RS-13-194

Braidwood Station, Units 1 and 2
Facility Operating License Nos. NPF-72 and NPF-77
NRC Docket Nos. STN 50-456 and STN 50-457

Subject: Response to Request for Additional Information - Overall Integrated Plan in Response to Commission Order Modifying License Requirements for Reliable Spent Fuel Pool Instrumentation (Order No. EA-12-051)

ATTACHMENT 1 Braidwood Spent Fuel Pool Elevation Sketch

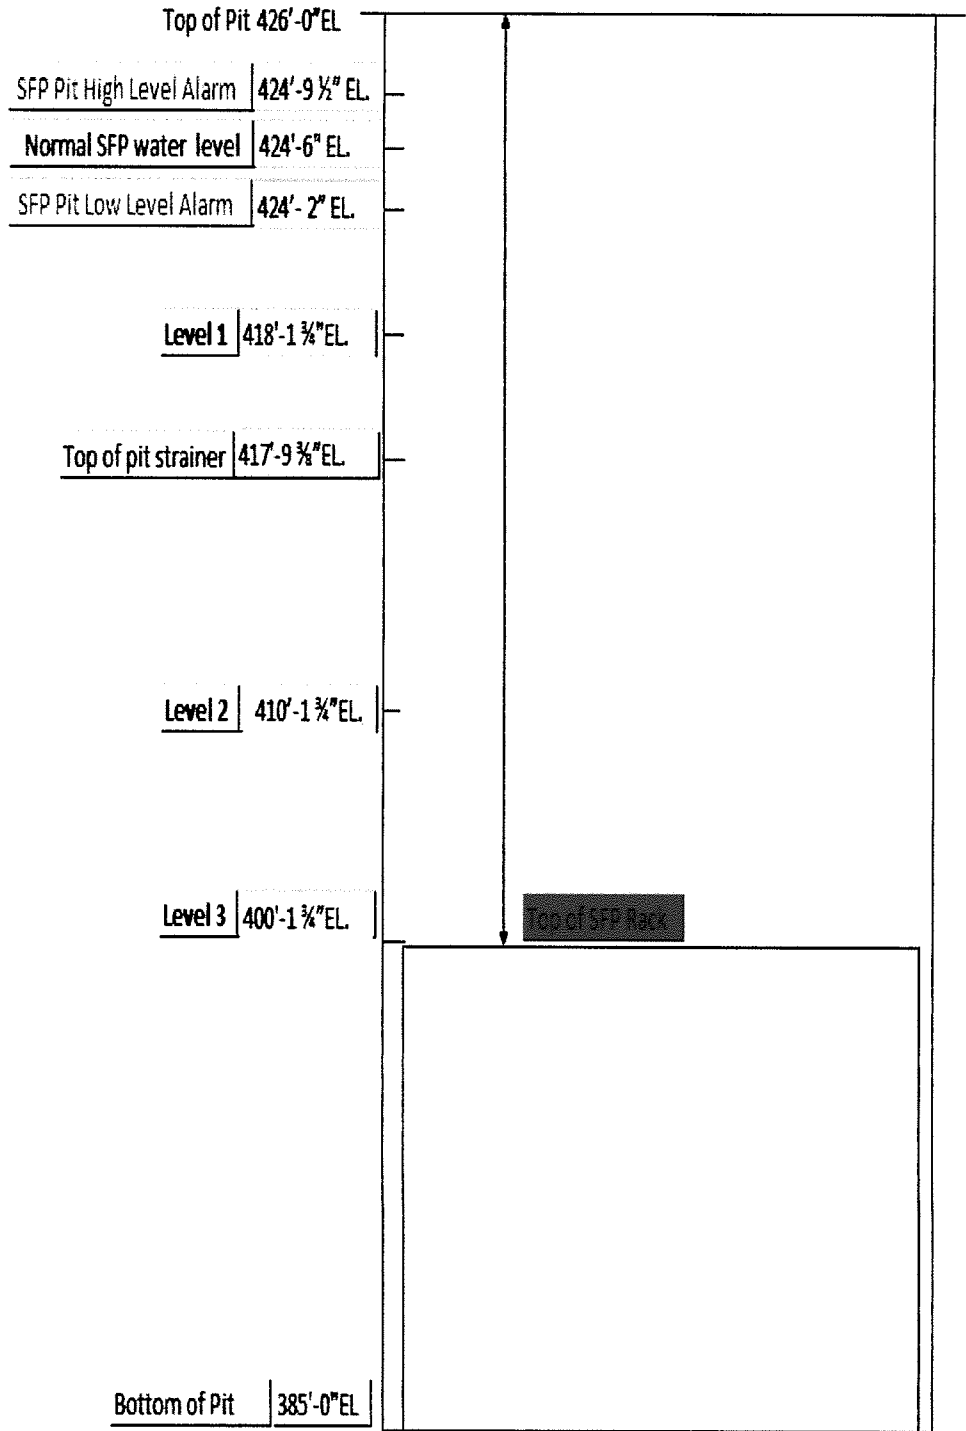
- a) For Level 1, specify how the identified location represents the higher of the two points described in the NEI 12-02 guidance for this level.
- b) A clearly labeled sketch depicting the elevation view of the proposed typical mounting arrangement for the portions of the instrument channel consisting of permanent measurement channel equipment (e.g., fixed level sensors and/or stilling wells, and mounting brackets). Indicate on this sketch the datum values representing Level 1, Level 2, and Level 3 as well as the top of the fuel. Indicate on this sketch the portion of the level sensor measurement range that is sensitive to measurement of the fuel pool level, with respect to the Level 1, Level 2, and Level 3 datum points.

- a) The Braidwood Spent Fuel Pool has two Spent Fuel Pool Cooling Pumps that take suction from the pool with the top of the suction strainer at the 417'-9-3/8" elevation. Normal Spent Fuel Pool Level is at the 424'-6" and low level at 424'-2". The detailed design will include a calculation to determine adequate water level to maintain normal fuel pool cooling system operation. This information will be available following acceptance of the 100% design, scheduled for April, 2014. The result will be provided in the August 2014, 6-month Integrated Plan update report to the NRC.
- b) A sketch is provided as Attachment 1, "Braidwood Spent Fuel Pool Elevation Sketch". Instrument probe mounting details in the Spent Fuel Pool area will be provided in accordance with our response to RAI-3.
